I am writing to request a Section 72 Amendment for the above planning permit.

As discussed, ongoing work at 81 & 83-91 Minerva Road, Herne Hill has caused changes to the site plan, and there are a number of flow on effects on the landscaping throughout the site. Additionally, the school has requested changes on the front façade to reorientate the signage reading “Holy Spirit Parish School” and requested new lighting to illuminate the updated signage.

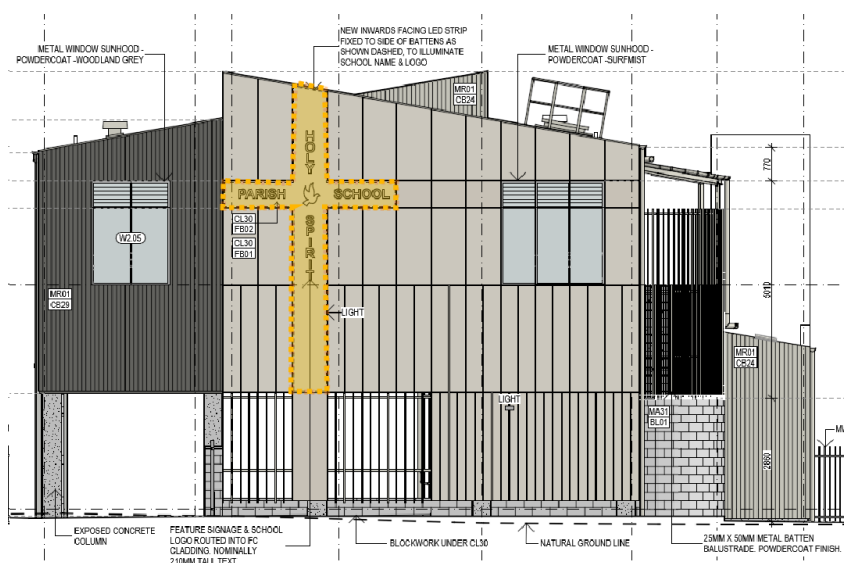
The school has requested changes on the front façade to reorientate the signage reading “Holy Spirit Parish School” and requested new lighting to illuminate the updated signage. The signage has been updated so that “Holy Spirit” runs top to bottom and “Parish School” runs left to right. The school’s logo will be located in the middle of the signage. Both the text & logo will be routed into the FC Cladding.

A new LED lighting strip is proposed to illuminate the signage fixed to battens, is indicated by a thick dashed line on the elevation and highlighted in the image below. The LED strip will face inwards, to illuminate the signage.

The amount of battens on the façade as been reduced due to the new LED light strip & change to signage orientation.
